SUBJECT: Approval of SHS Draft Change Order No. 67 – Additional Cooling - \$268,810.00

#### **CHANGE ORDER**

Change Item: 632 - CCD-218 Additional Cooling

#### CONSTRUCTION CHANGE DIRECTIVE: CCD-218R1 ADDITIONAL COOLING SYSTEM

PARTIAL THIRD FLOOR **PLUMBING** PLAN

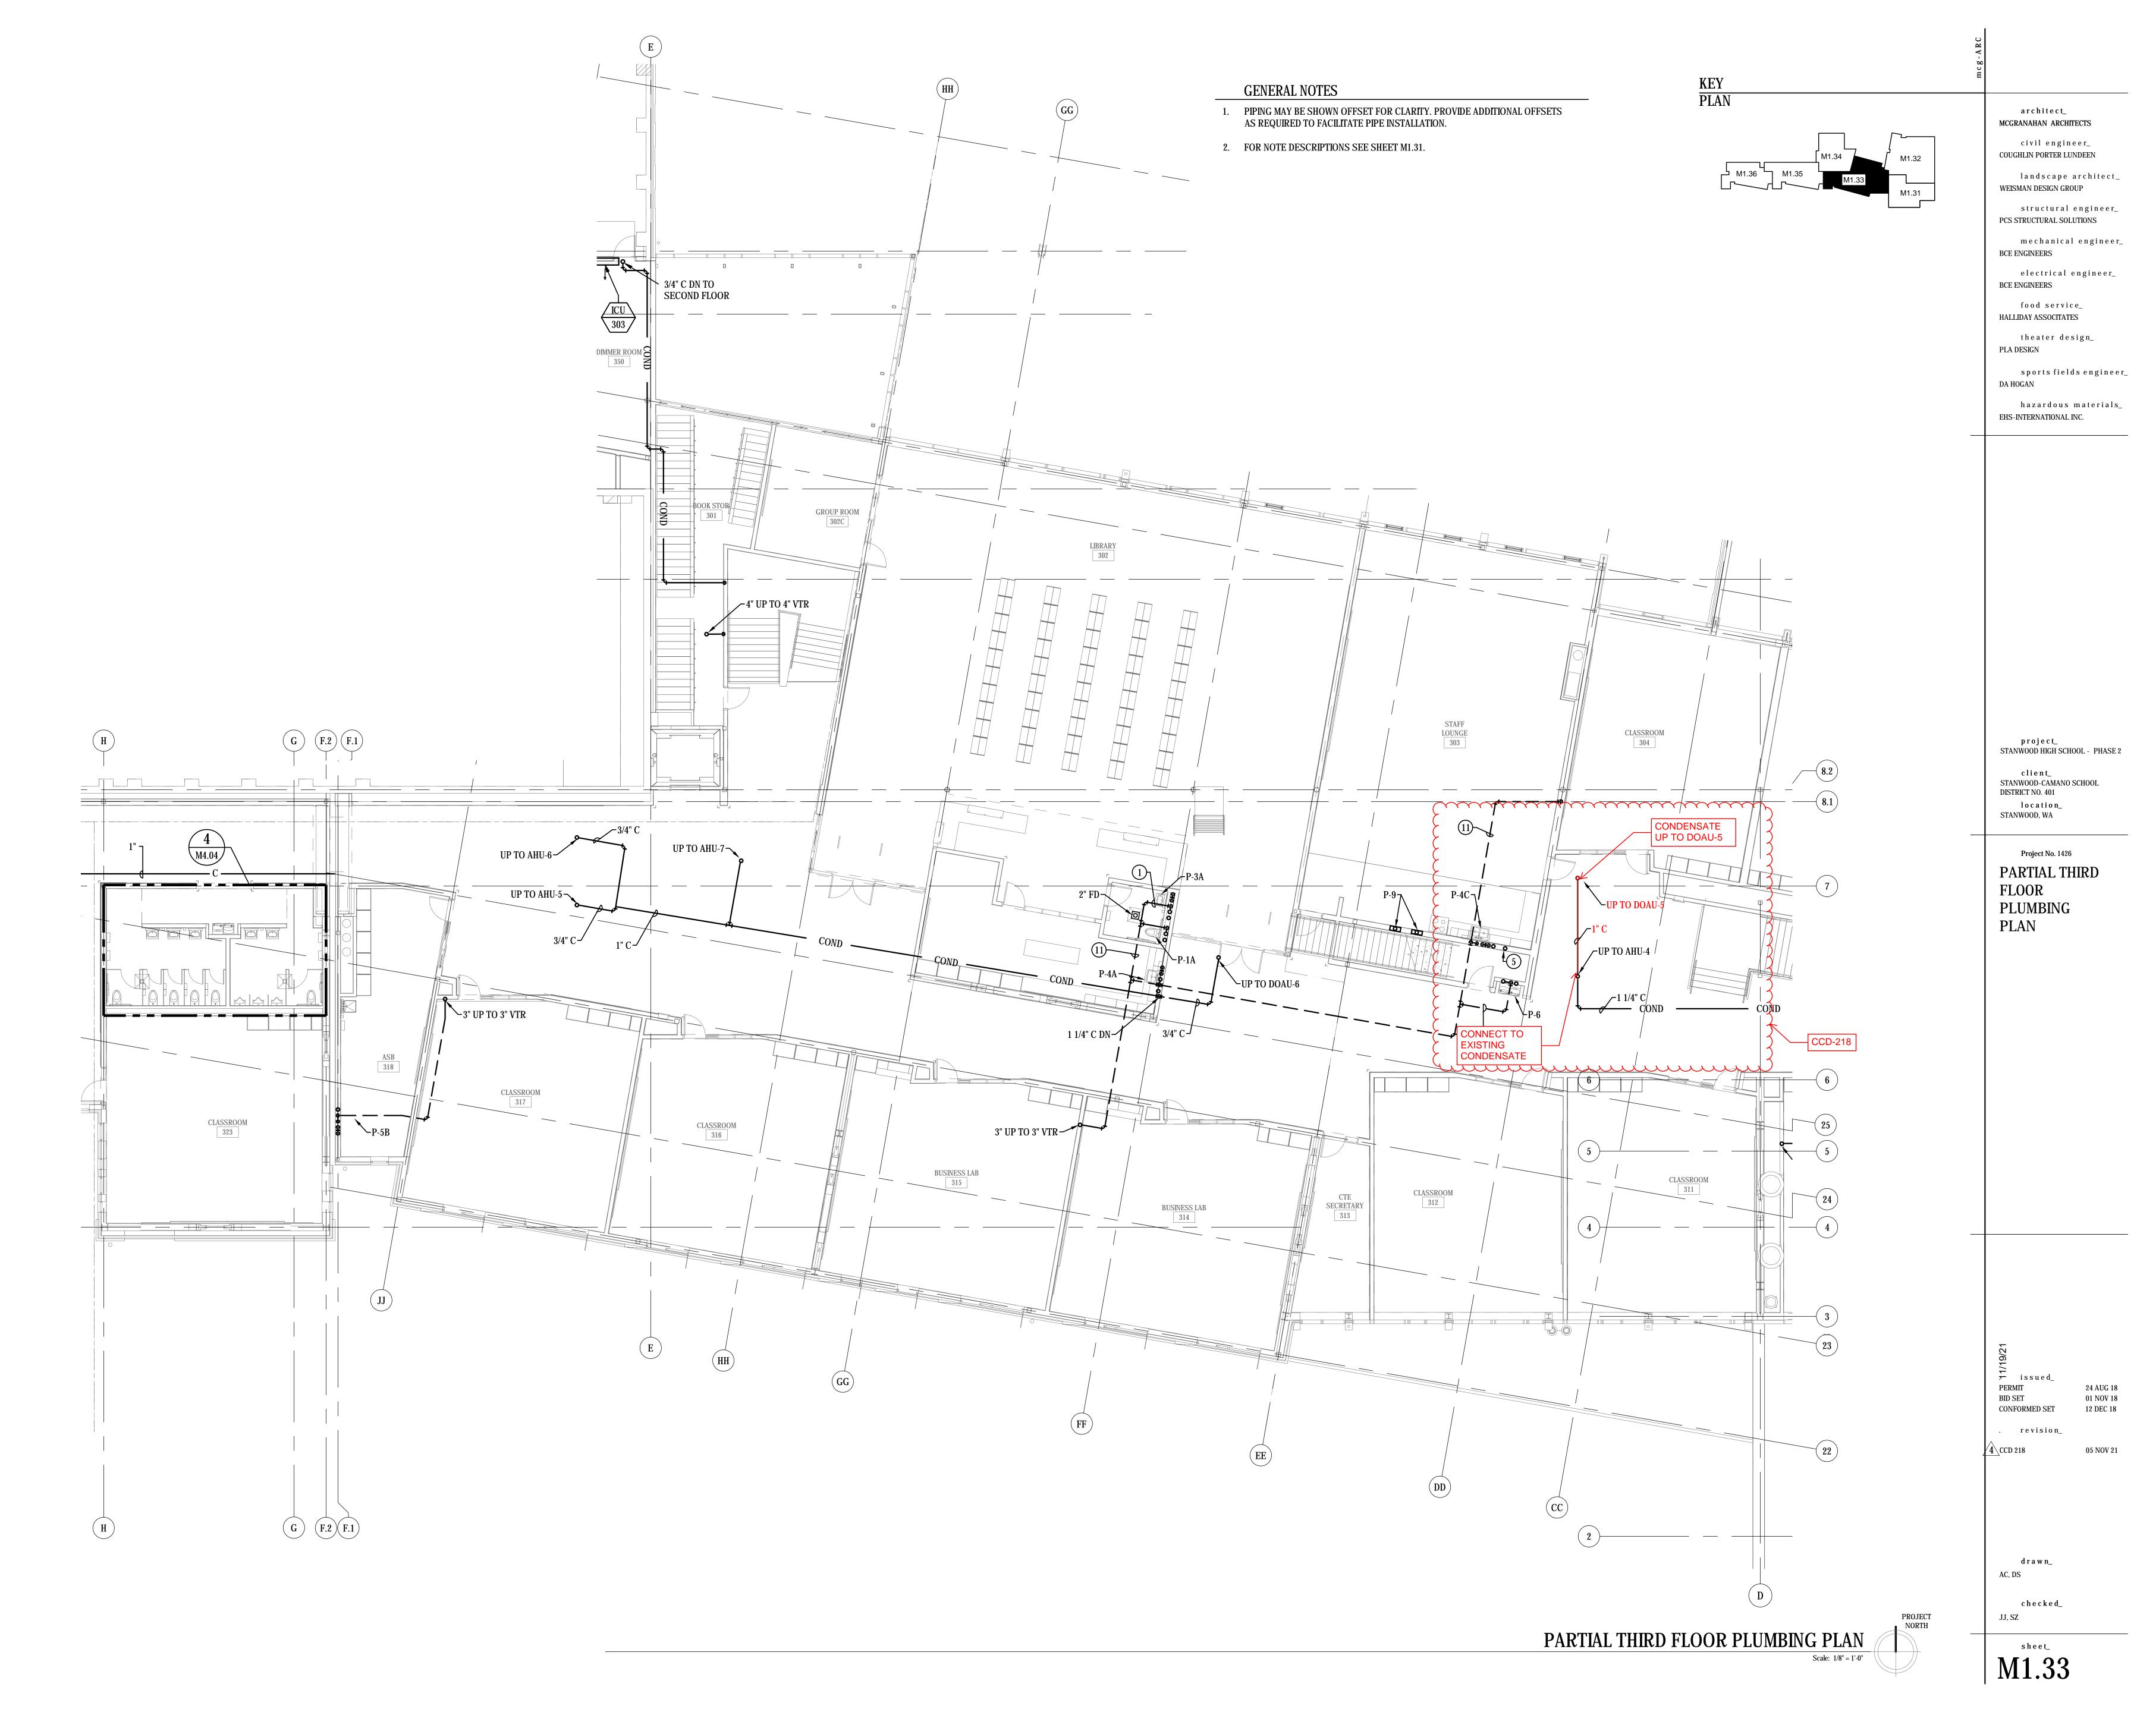
issued\_ 01 NOV 18 12 DEC 18 CONFORMED SET PERMIT RESUB 19 FEB 19 revision\_ ADDENDUM 1 14 NOV 18 05 NOV 21 4\CCD 218

PARTIAL THIRD **FLOOR HVAC** PLAN

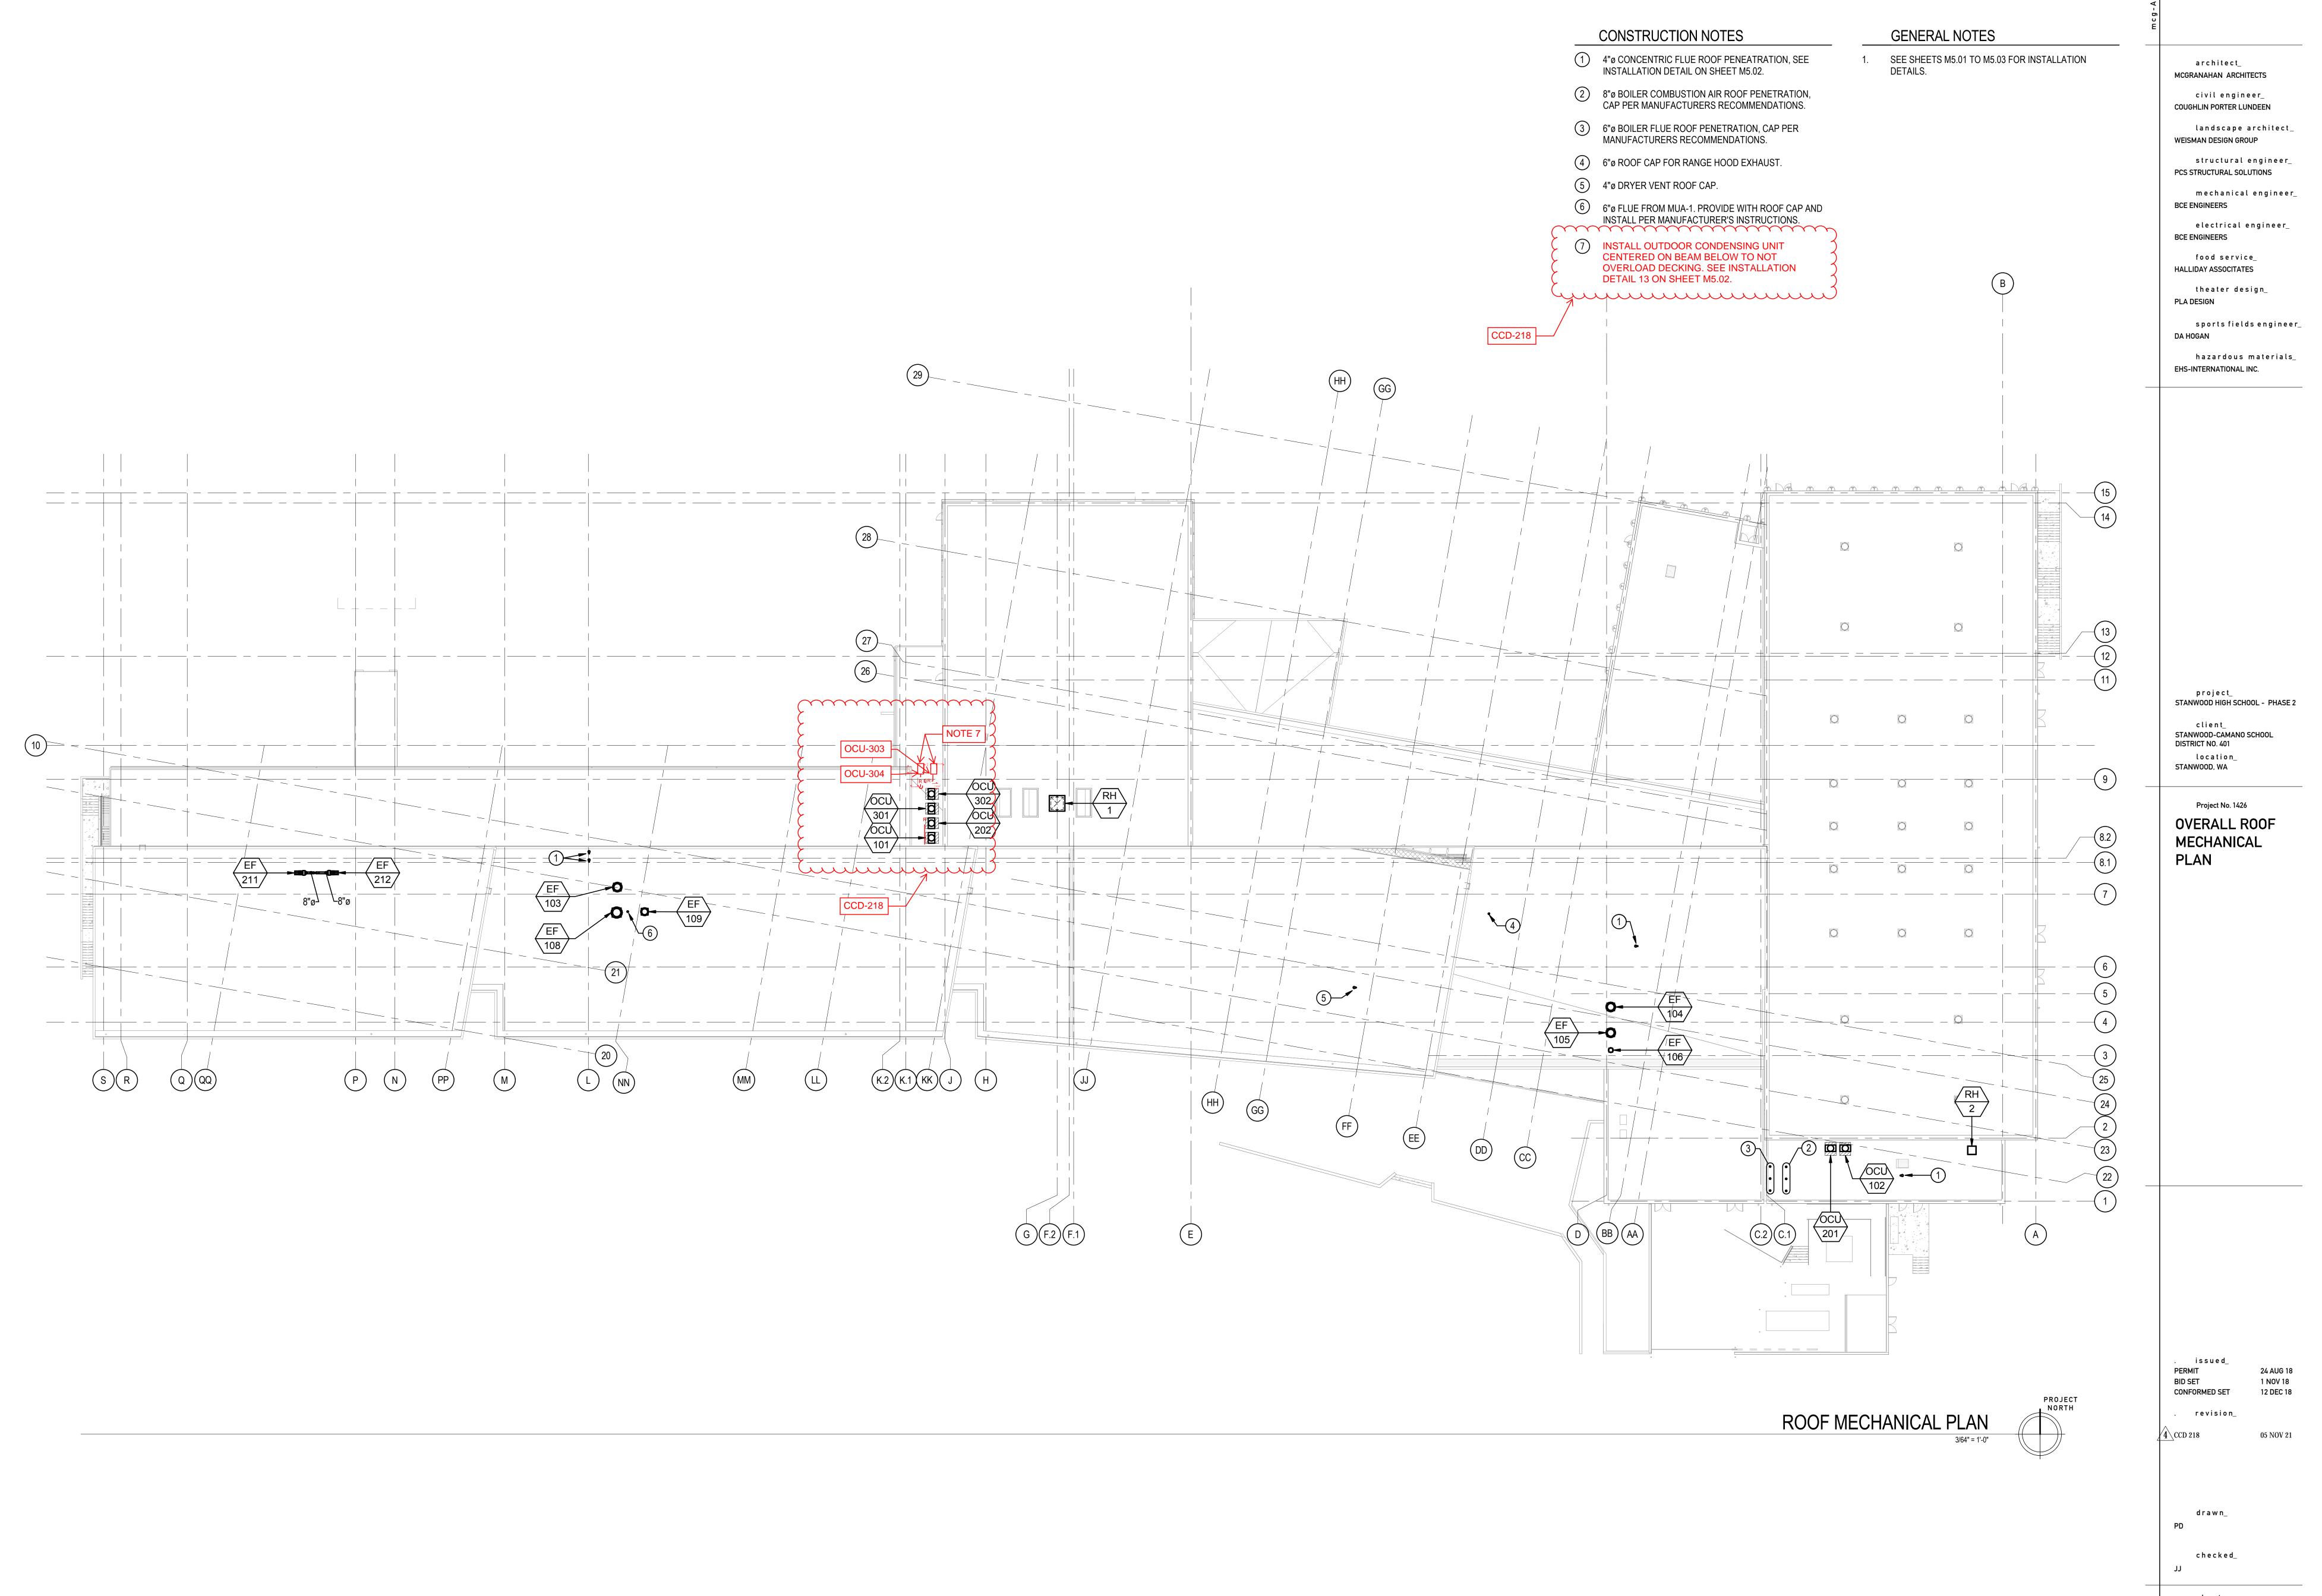
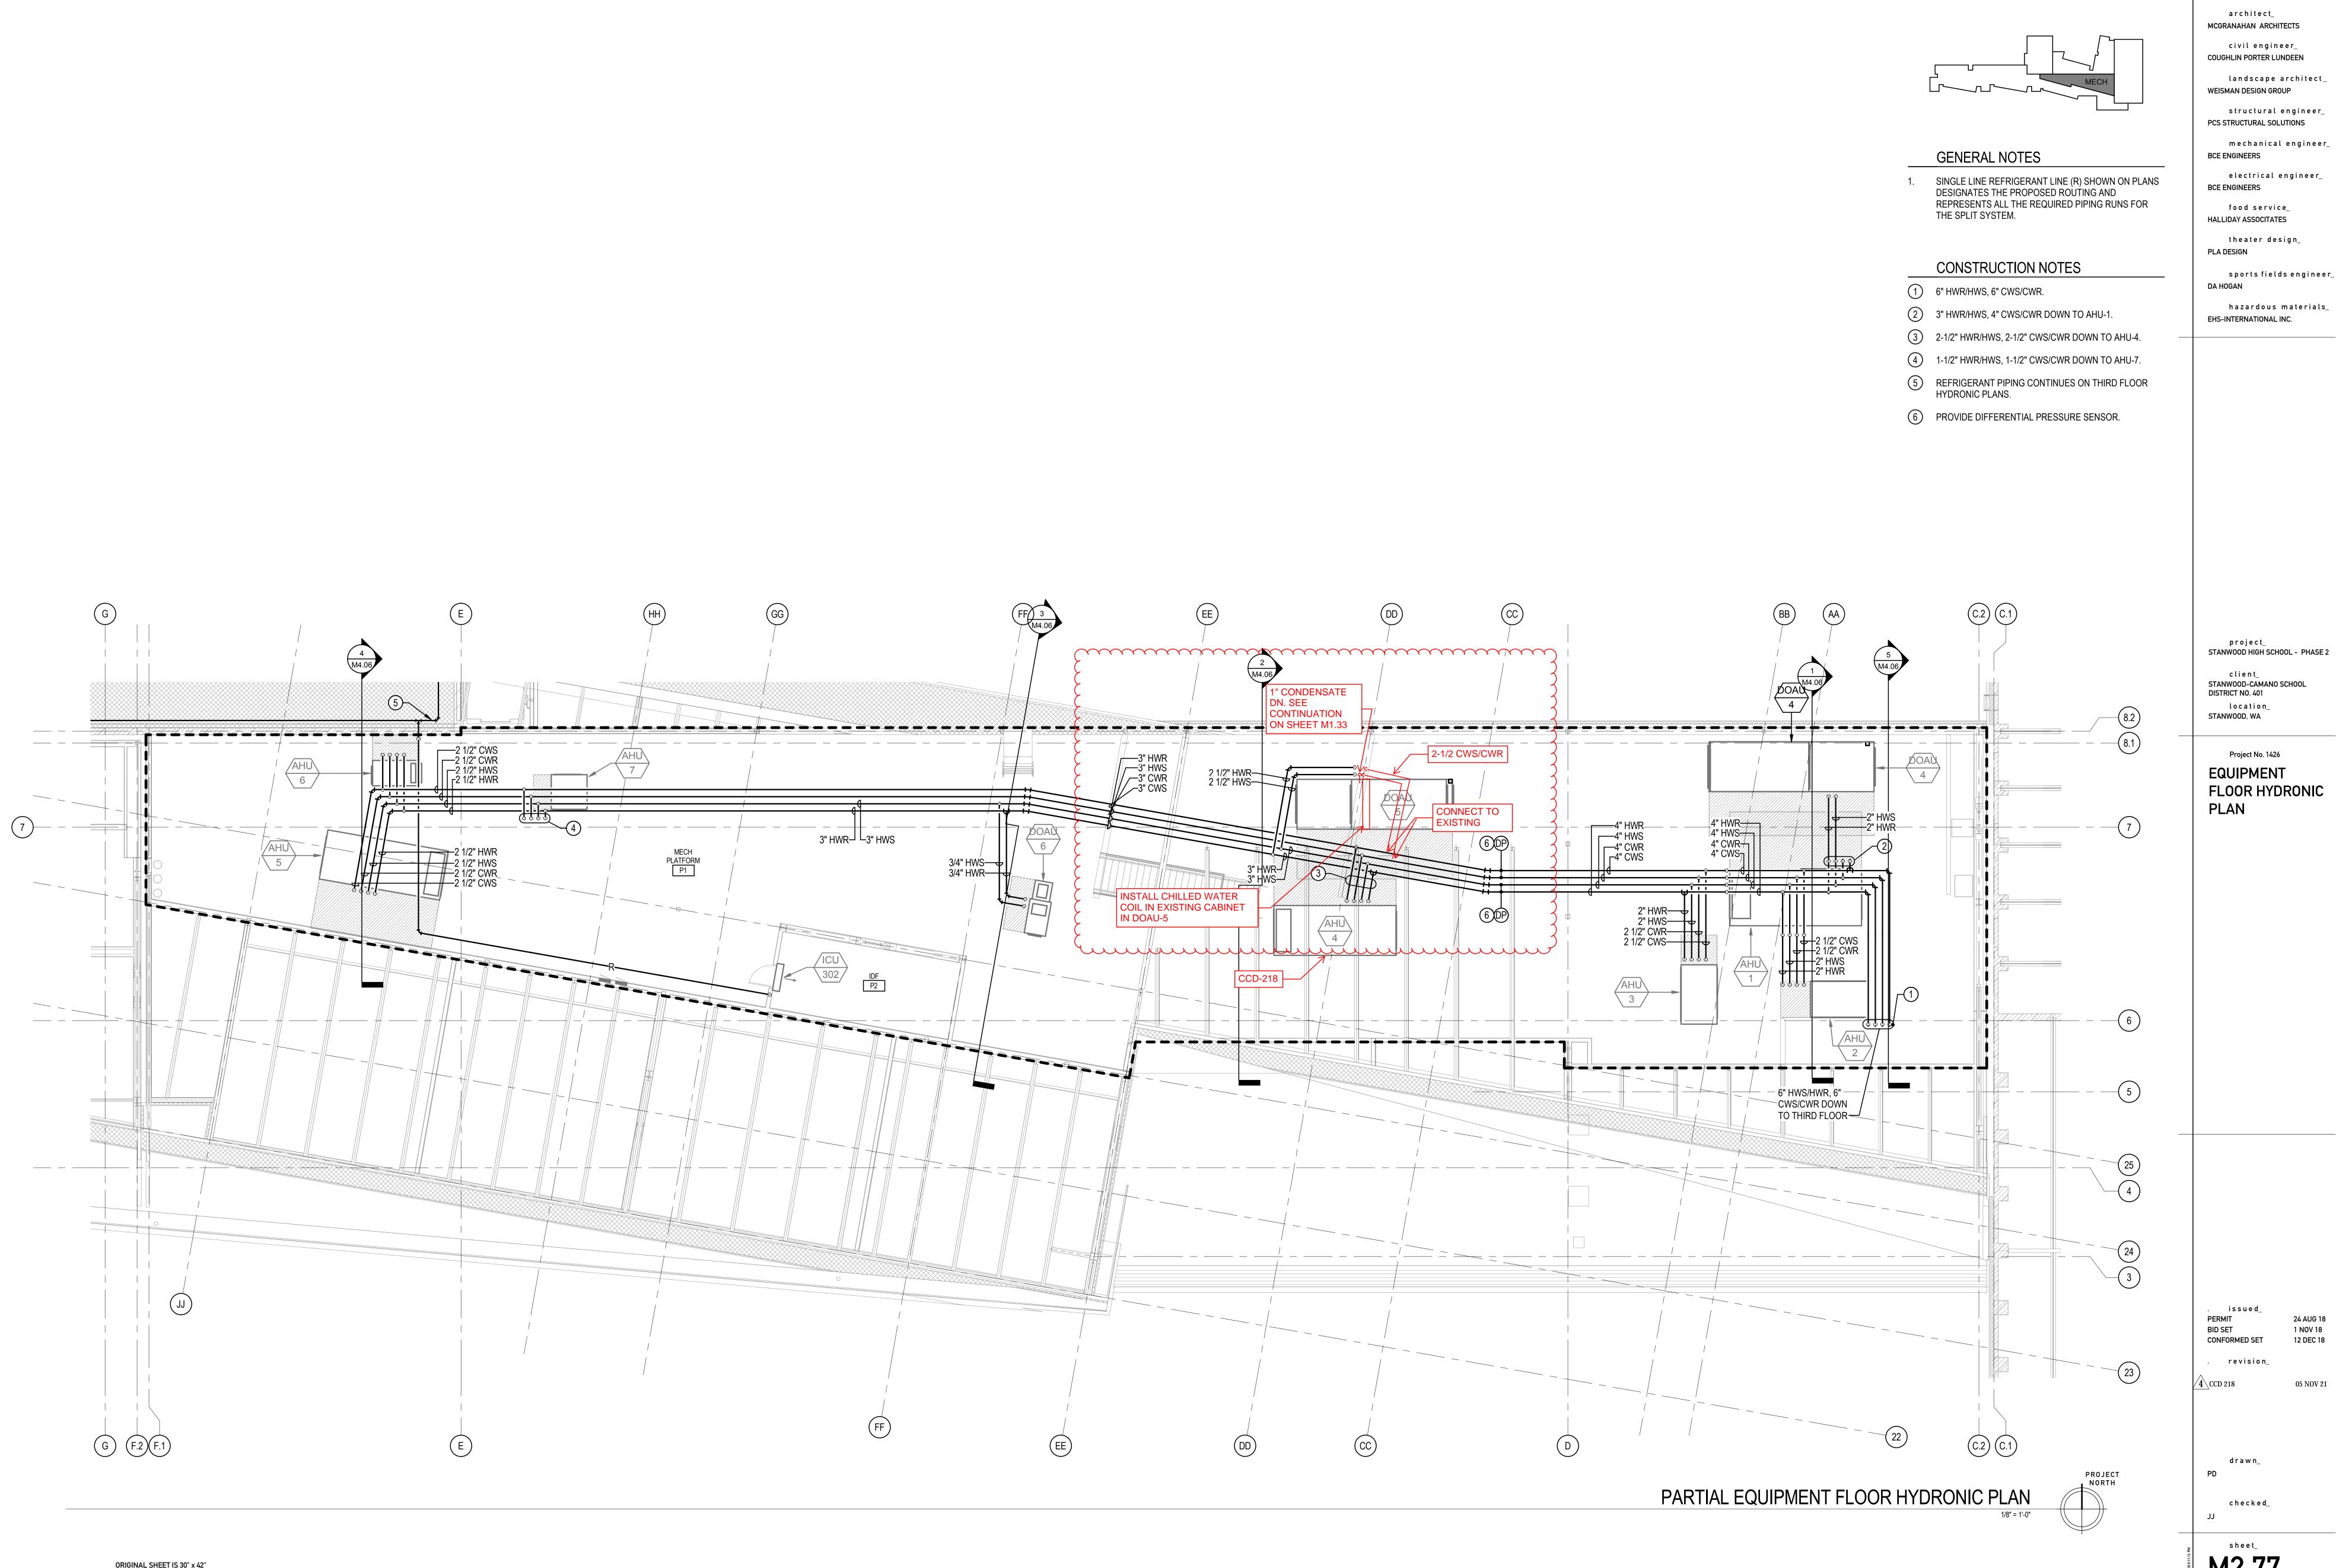
Provide adding additional cooling in Stanwood High School. Scope is to include providing a new hydronic cooling coil to be installed in DOAU-5. New coil to be connected to existing hydronic system. Two new DX cased coils to be installed on 3<sup>rd</sup> floor branches of DOAU-2 ductwork serving the 3<sup>rd</sup> floor. Additional controls to be added per drawing revisions on sheets M6.04 and M6.05. Corresponding outdoor condensing units be installed on the roof. COP cost to include programming, sensor, wiring, conduit, devices and ALL appurtenances as required for a complete & operational system.

revision\_ 4\CCD 218
